St. Johns River Water Management District

DATE: November 1, 2021
TO: Prospective Respondents
FROM: Amy Lucey, Procurement Specialist
SUBJECT: Addendum #1 to Invitation For Bid, # 37379, Fabricate/Manufacture New Walkway Platforms

(S4) / 4 HANDRAIL DETAIL
NOT TO SCALE

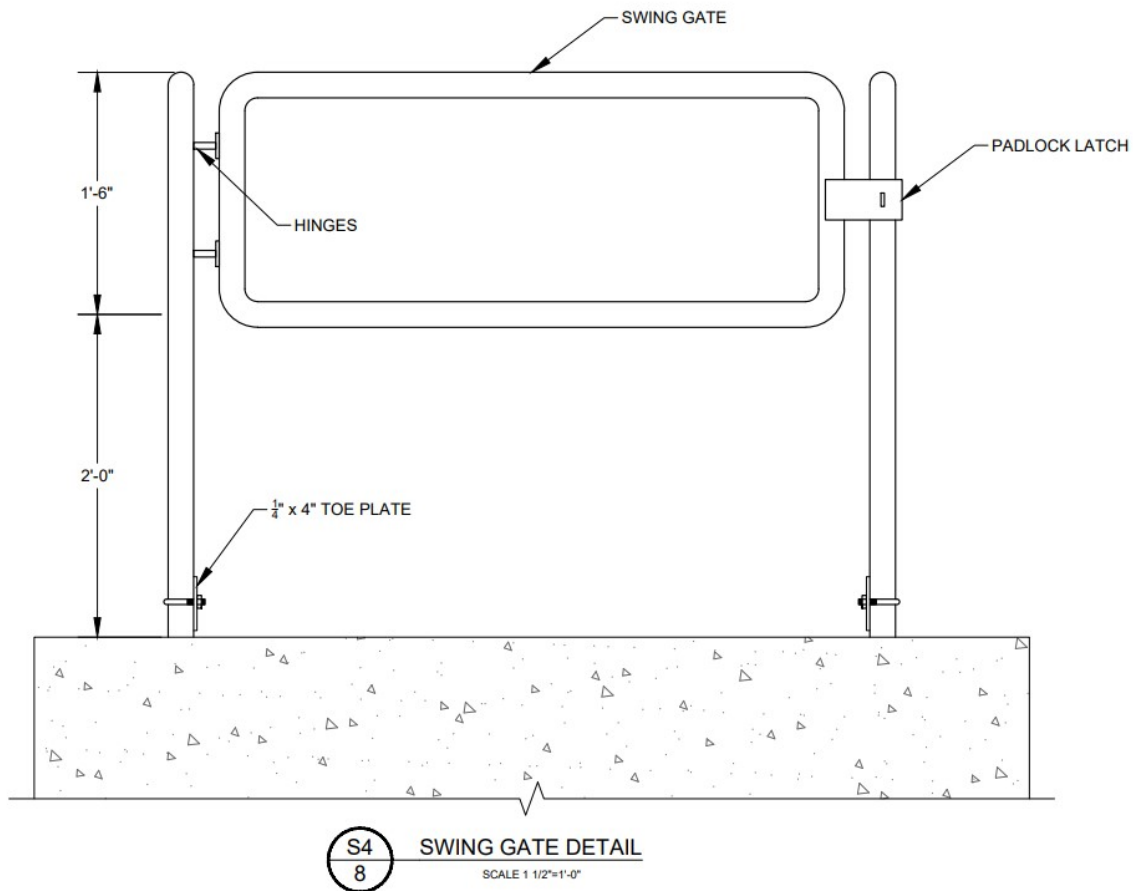
Q5: The highlighted red piece looks like an angle but is pointed to as a plate. The weld for the tubing to the TAB with 2 holes is clear... the weld from the angle to the channel piece is clear... but there is no weld symbol shown for the angle to the TAB (what is it?)

A5: Please see answer 2 above.
